# **Monitoring Report MY05**

**Stony Fork Restoration Site  
Upper Neuse River Basin - 03020201  
Monitoring Year 05  
DMS Contract 6830**

## MEMORANDUM

Date: February 26, 2024  
To: Danielle Mir, DMS Project Manager  
From: Adam Spiller, Project Manager  
KCI Associates of North Carolina, PA  
Subject: MY-05 Monitoring Report Comments  
Stony Fork DMS #6830, Contract 006830  
Neuse River Basin CU 030202018  
Johnston County, North Carolina

**SHEET 1 of 4**  
 Source: Google Earth, 2018

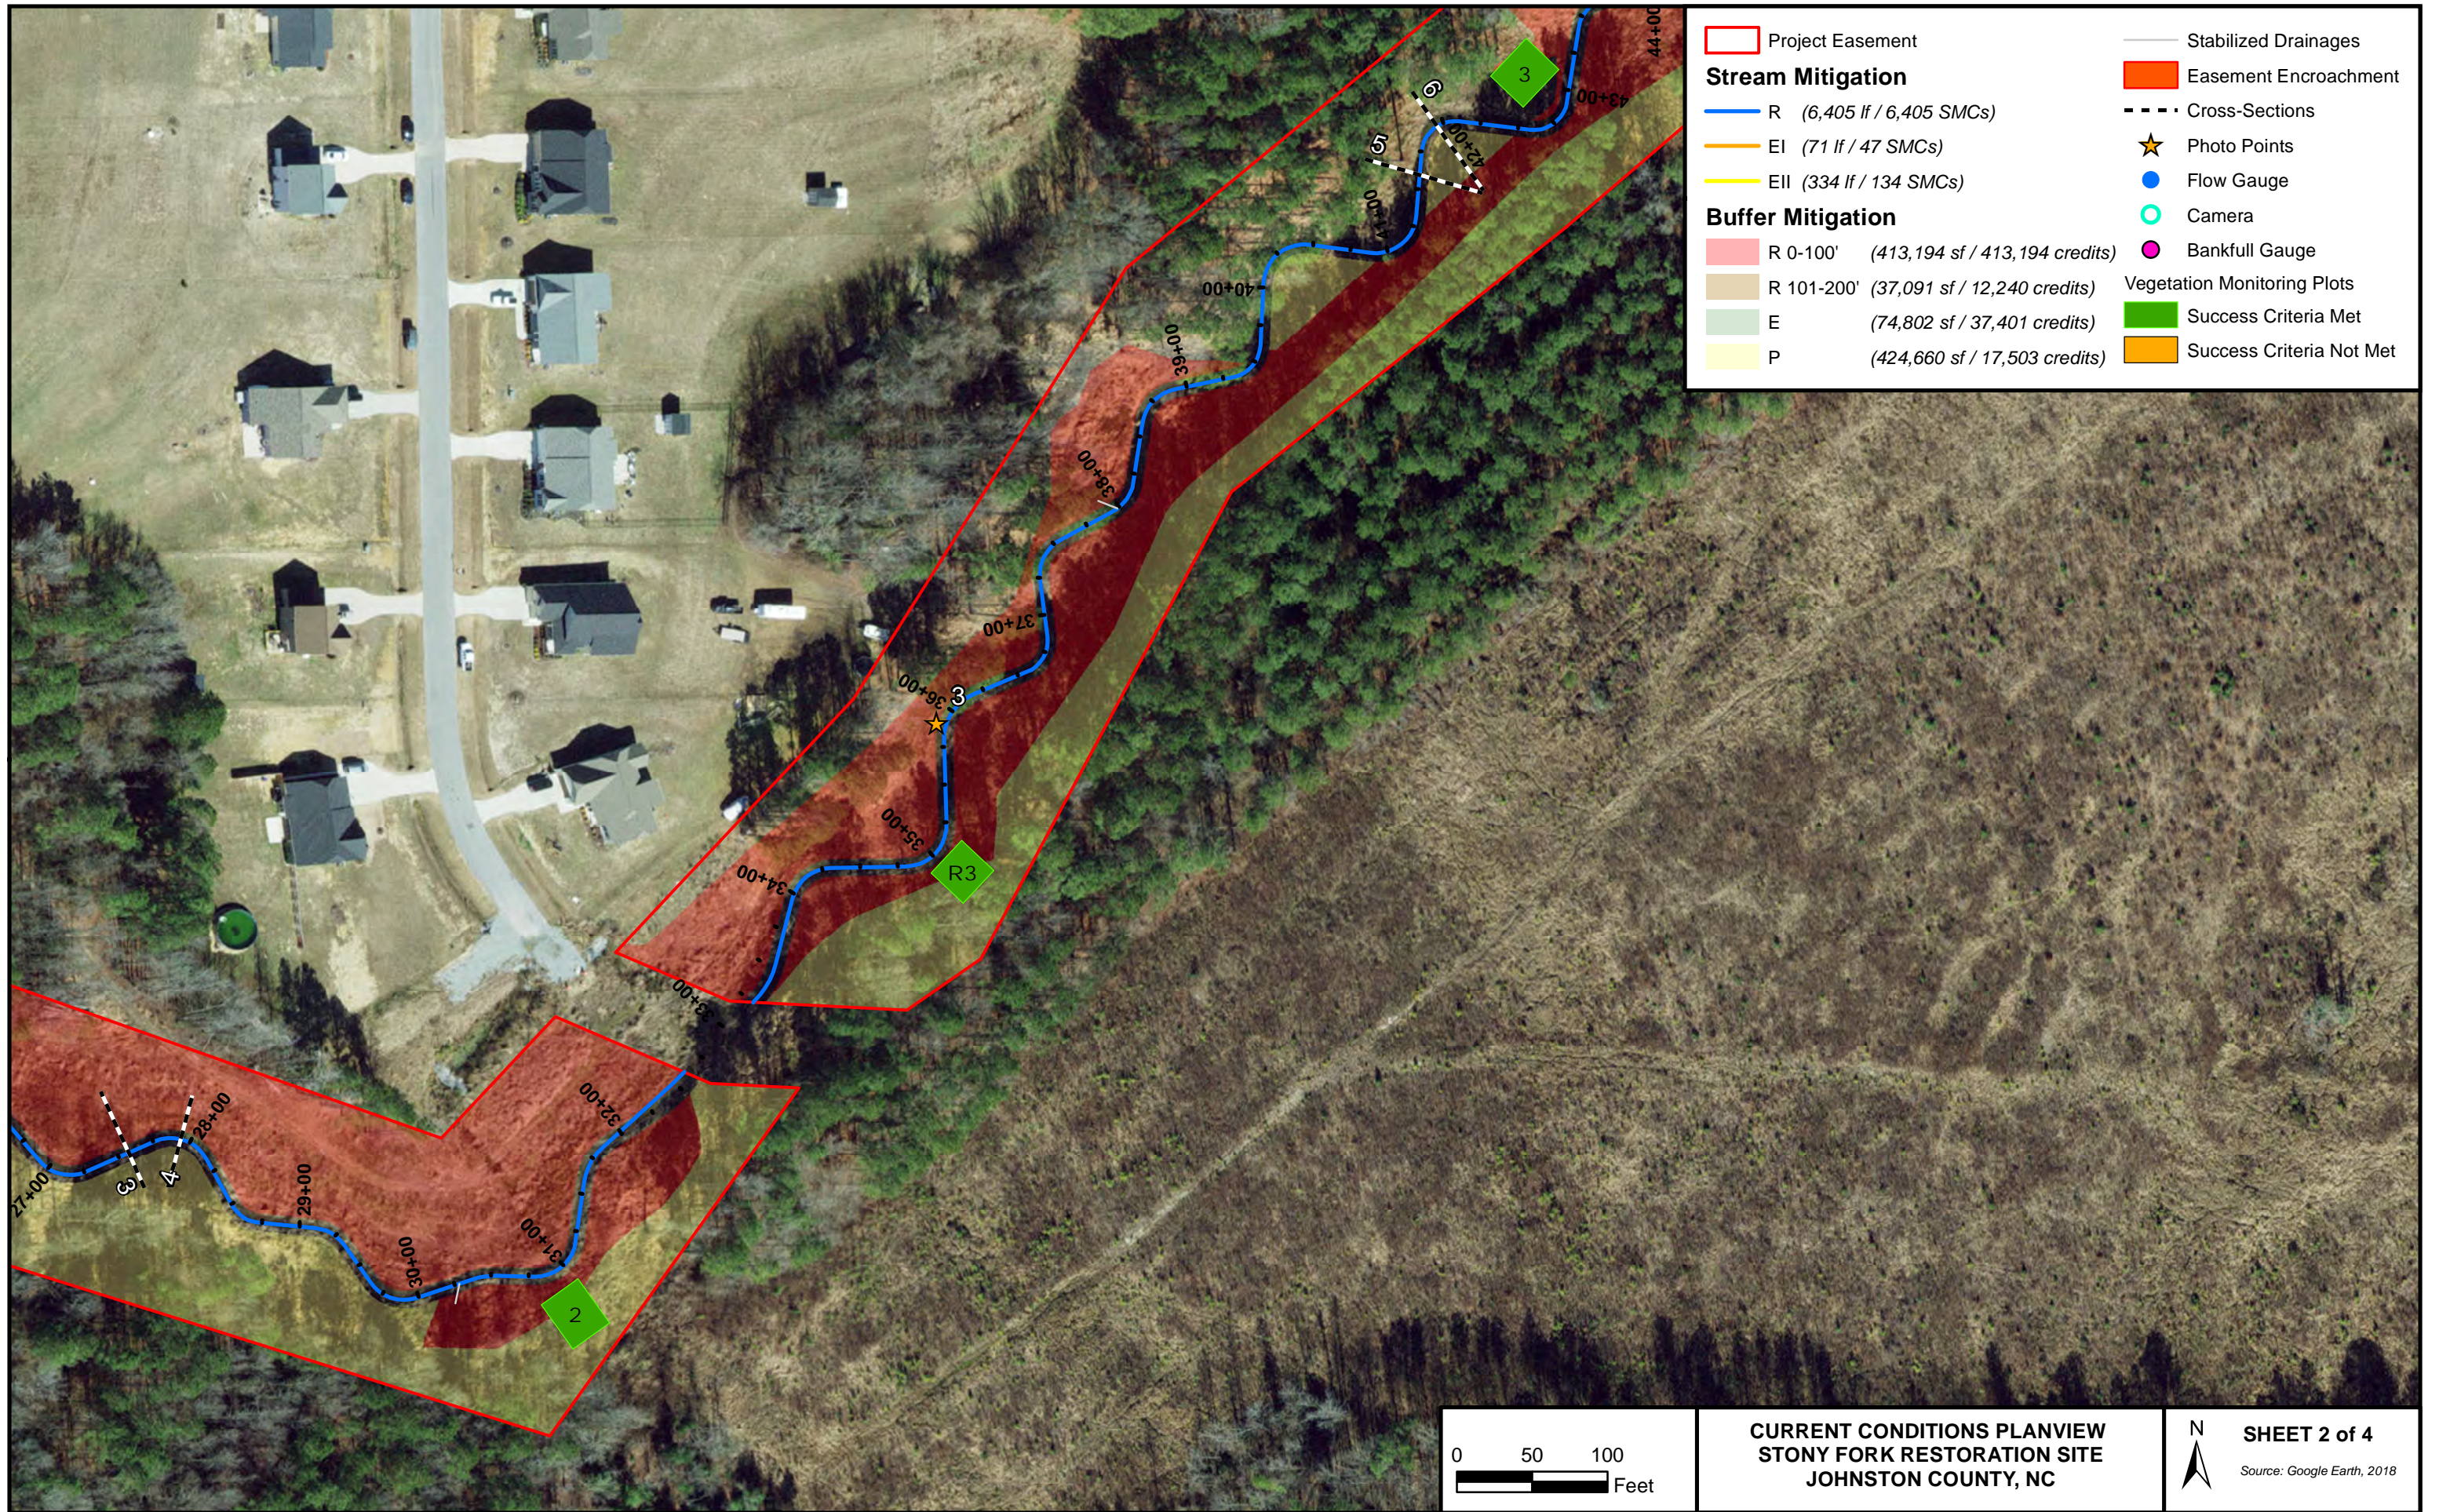
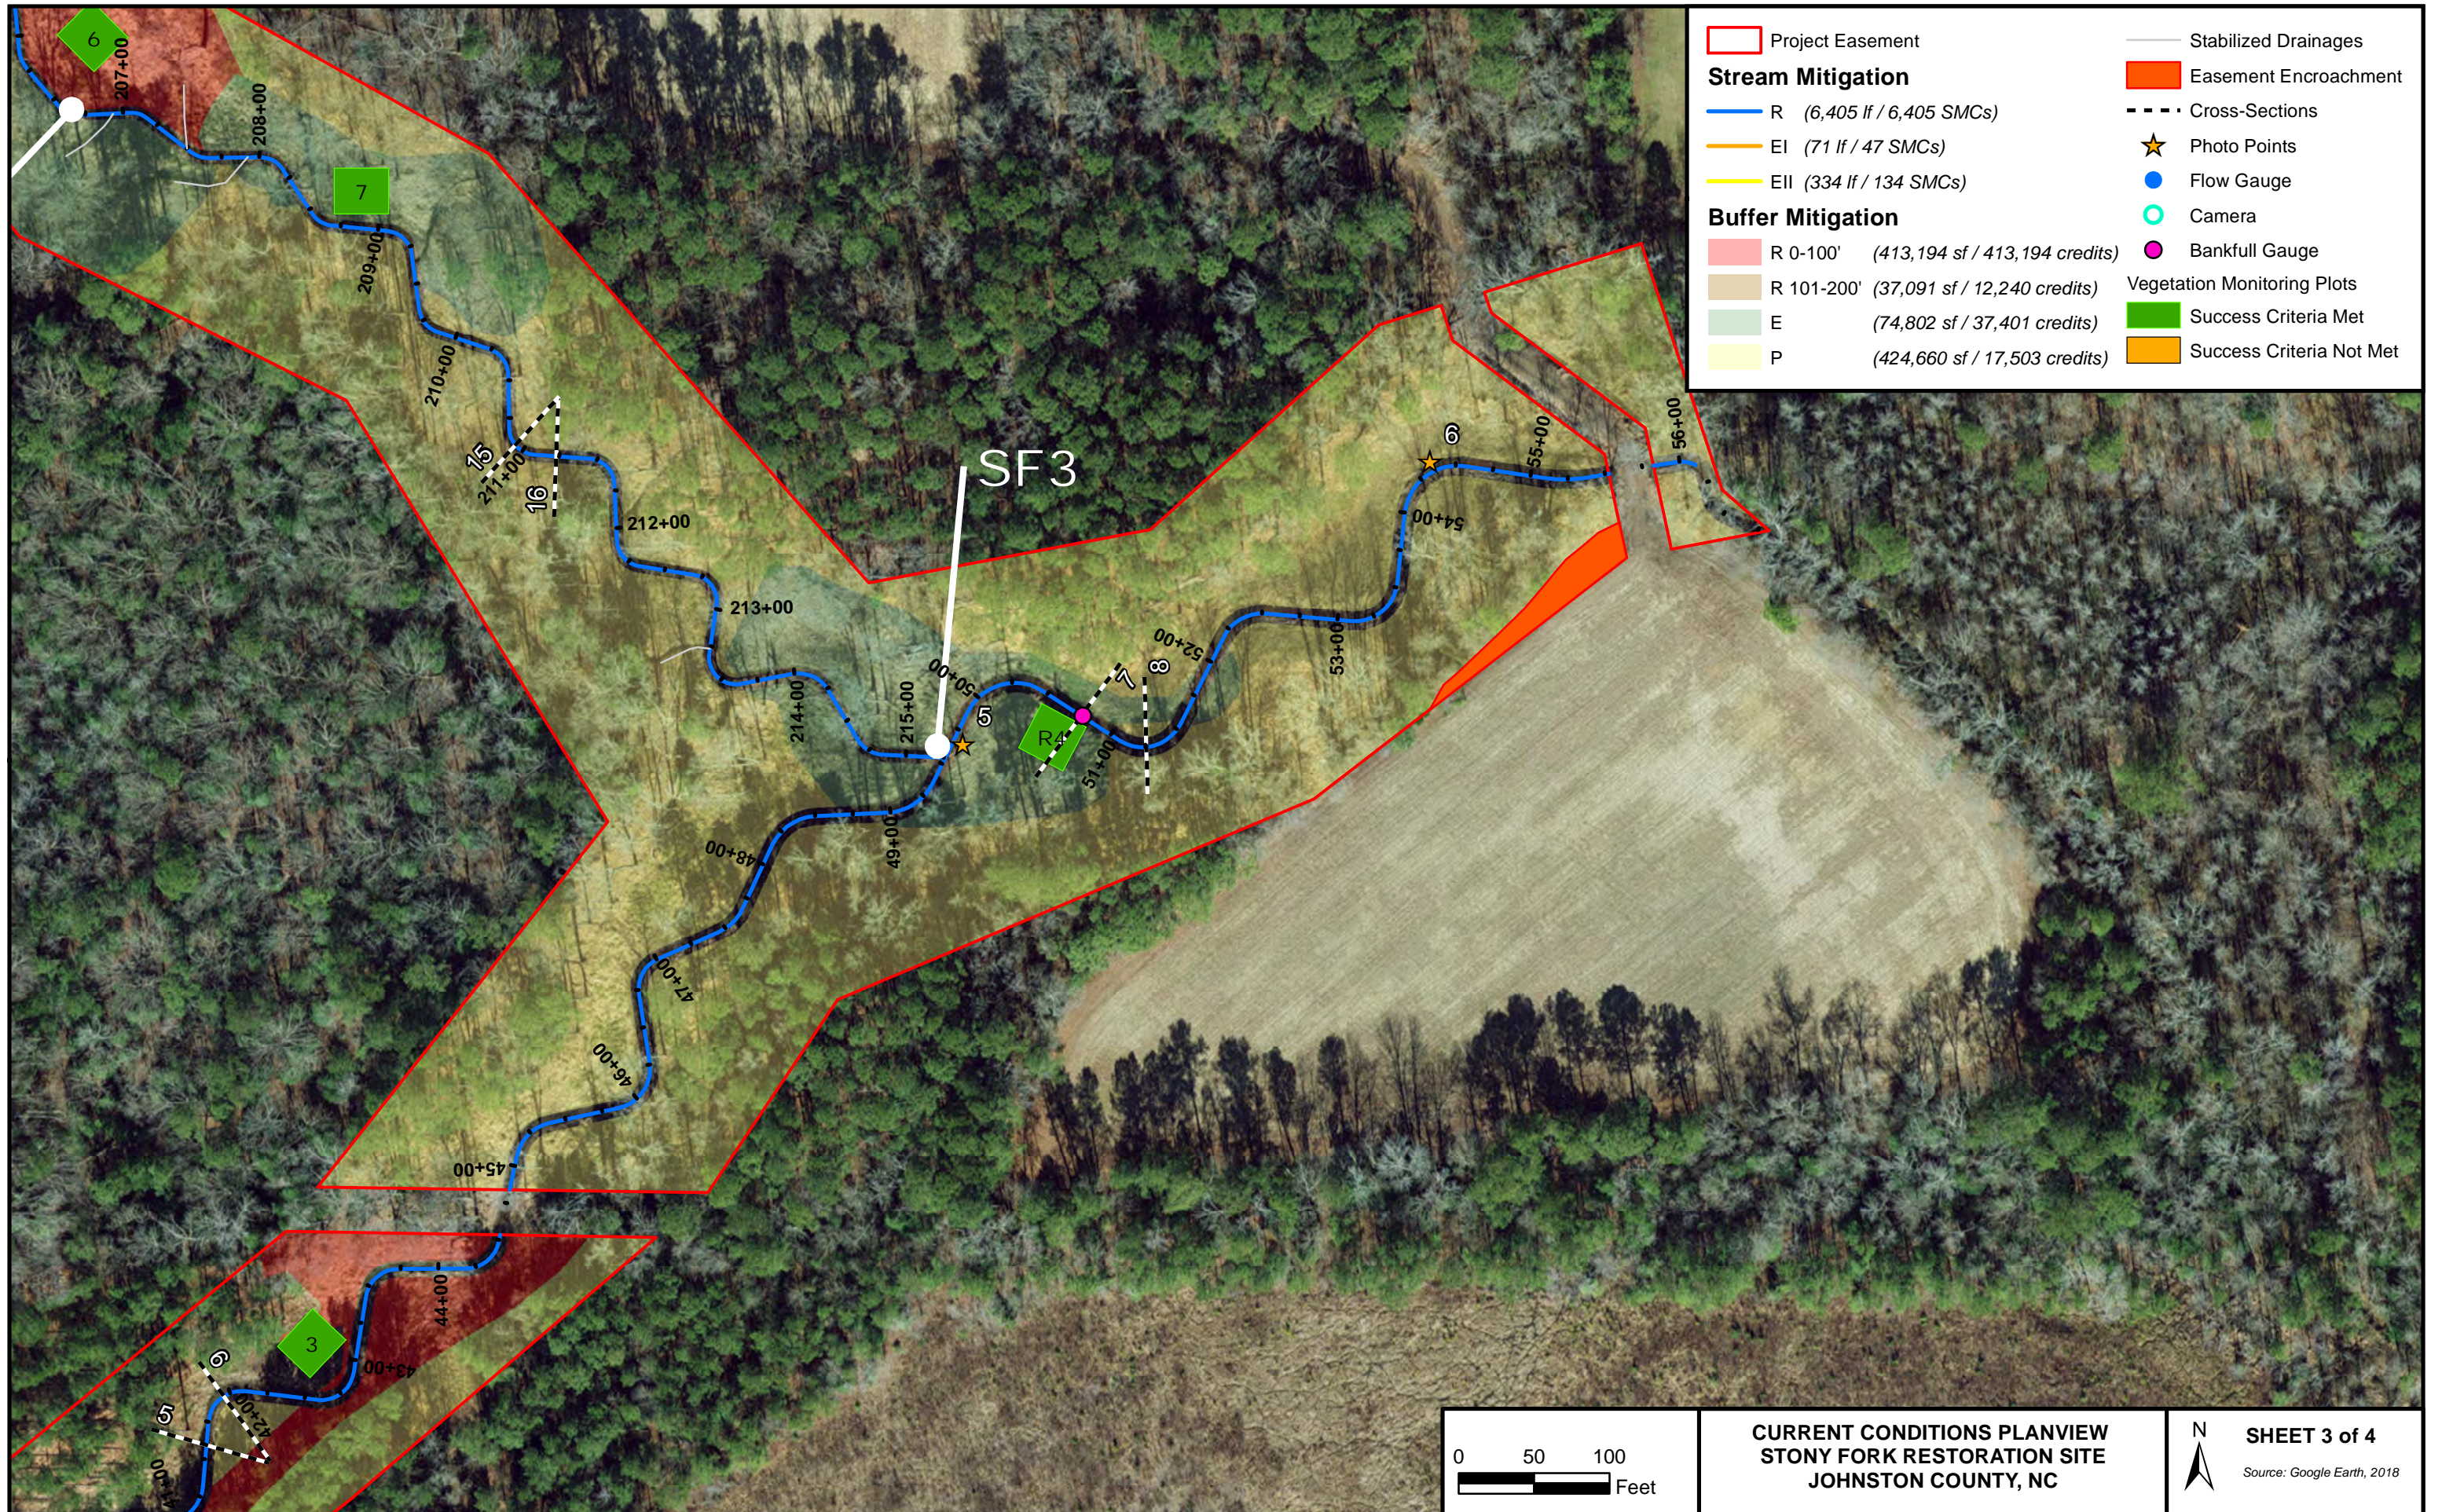
1. Table 1 - Please display credits to 3-decimal places.  
*KCI Response: This error has been corrected.*
2. CCPV – DMS recommends showing the non-credited streams inside the easement with a symbology of a grey /black line labeled “non-credited stream.” Below is a rough sketch of the estimated locations of these streams.  
*KCI Response: At the start of the project, the features in question were determined to not constitute streams. These ephemeral drains were stabilized as part of the project and have been added to the CCPV and labeled “Stabilized Drainages.”*
